# Transit Mall Feedback

A Response to the “Portland Transit Mall Revitalization Conceptual Design Report”

October 21, 2003

Bob Richardson

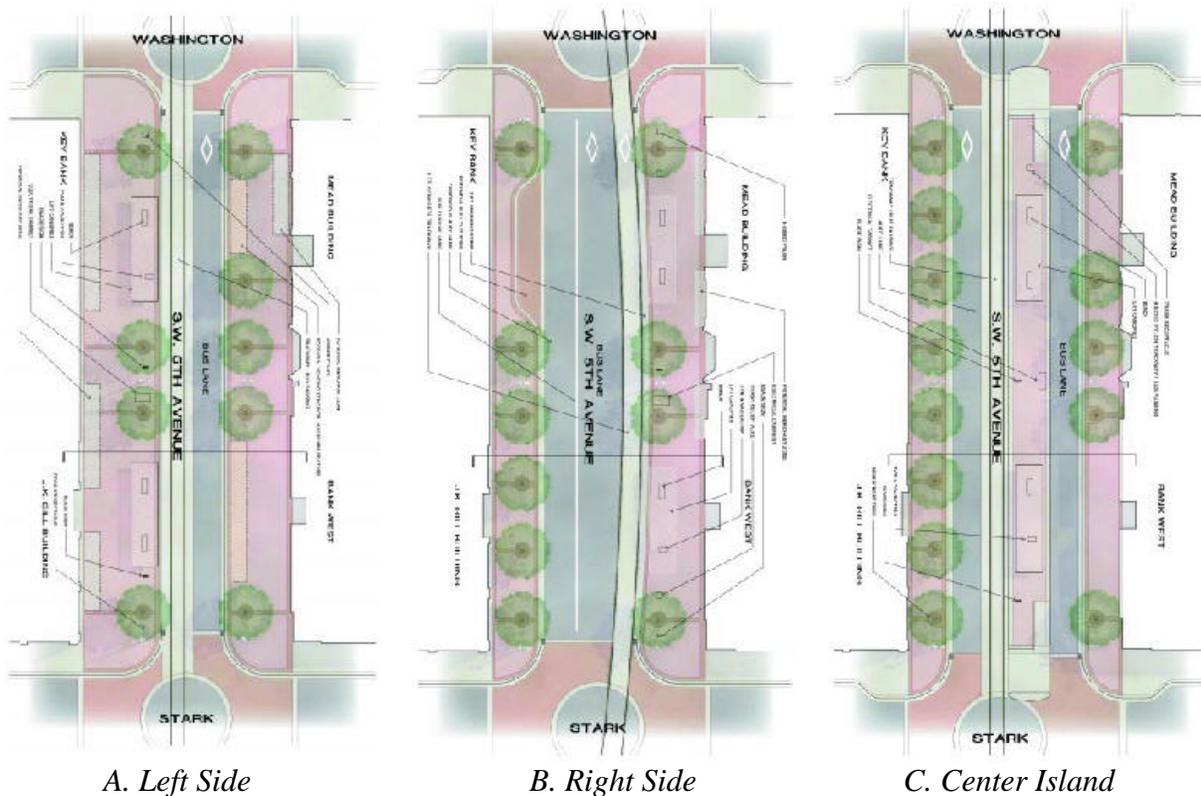
The proposed alignment from Union Station southward should provide excellent service along the spine of downtown.

It is recommended that funding options be pursued to implement the full proposal all the way south to the PSU campus for maximum ridership and flexibility in train turning and scheduling.

*Option "D"*

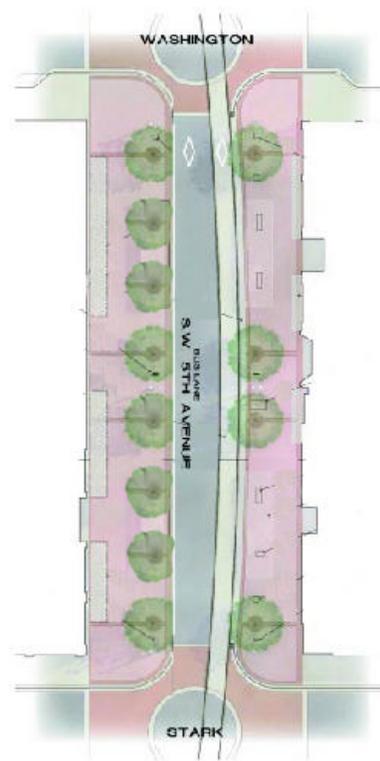
It should be noted that the existence of Option B (Right Side) creates the opportunity to consider a new fourth option:

Option D (Right Side – Preserve Left-Side Pedestrian/Art ROW):

Because Option B allows trains and busses to crisscross paths operationally, all light rail boarding is accomplished on the right-hand side of the street. Therefore, if no automotive through-lane is established, all existing wide sidewalks featuring pedestrian areas, art and fountains could be maintained.

If the public demands that the existing pedestrian orientation with no auto access be maintained, option D may be an ideal solution.

*Recommended:  
Colored/textured full-depth concrete would mimic the current treatment.*

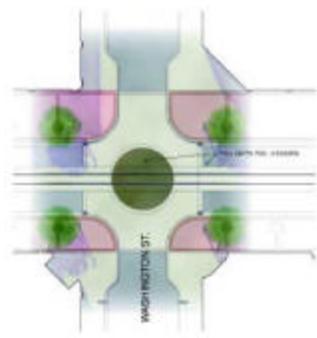
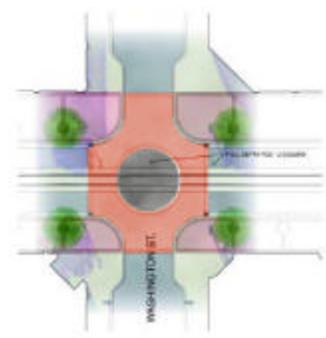
The Conceptual Design Report shows several alternatives. Because of the public benefit of preserving an attractive Transit Mall appearance reflective of the other high quality materials in the mall, the pure asphalt with thermoplastic stripping method would be undesirable.

Using less expensive, easily maintained materials is a worthy goal, but must be done in a way that preserves the overall look of the current treatments. The suggested alternative of replacing existing materials with full-depth concrete is intriguing, and would be acceptable if the concrete can be colored (and perhaps textured) to simulate the current red paver layout.
